ATOM 35 CONTENEUR PRINCIPAL  
MAIN CONTAINER

**Configuration:** Main container packed with spring pilot chute.  
**Incident Origin:** After pulling out the main ripcord, the closing loop's of the main container may delay the exit of the pilot chute.

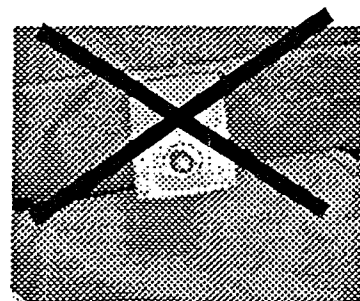
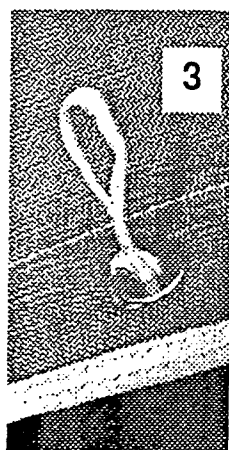
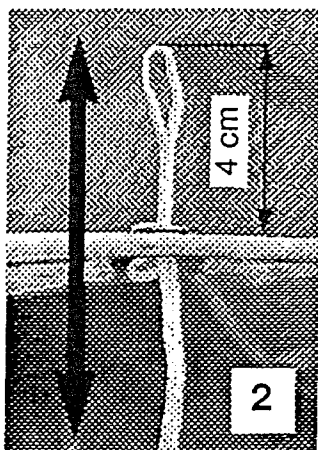
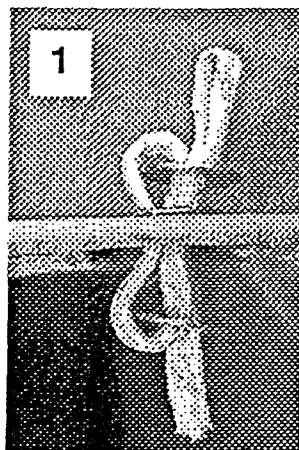
**Configuration:** Conteneur principal plié avec extracteur à ressort.  
**Origine de l'incident:** Lors de l'action d'ouverture du conteneur principal, l'arrimage de la bouclette sur sa patte de fixation peut générer un blocage et un retard de jaillissement de l'extracteur.  
**Remède à apporter:** Fixer la bouclette de fermeture sur le rabat inférieur du principal selon les schémas ci-dessous. Inverser l'ordre de fermeture des rabats latéraux:  
**Fermer dans l'ordre:** 1) Rabat inférieur avec bouclette, 2) rabat latéral droit, 3) rabat latéral gauche, 4) rabat supérieur.

**Modification:** Install the main closing loop on the lower flap of the main container as shown on pict N°1,2,3  
 Invert the flaps closure's order: 1) Lower flap (locking loop) 2) right flap, 3) left flap, 4) upper flap.

Passer la bouclette selon le dessin N°1 en prenant la précaution de mettre la partie lisse de chaque rondelle à l'extérieur et la partie pouvant comporter la bavure de découpage vers l'œillet.  
 - Ajuster la longueur utile de la bouclette à une longueur d'environ 4 cm.  
 - Bloquer l'ensemble selon le dessin N°2  
 - La patte d'attache d'origine n'est plus utilisée  
 \* La bouclette d'origine est livrée avec 1 rondelle.  
 Le montage nécessite une rondelle supplémentaire

- Install the locking loop as shown in drawing N°1 taking good care of positioning the sliding side of each washer outside the grommets.  
 - Adjust the length of the loop to about 4 cm.  
 - Pull the two parts of the loop (drawing N°2)  
 - The original attachment loop is not used anymore  
 \* The original loop is delivered with 1 washer.  
 The assembling requires another one.
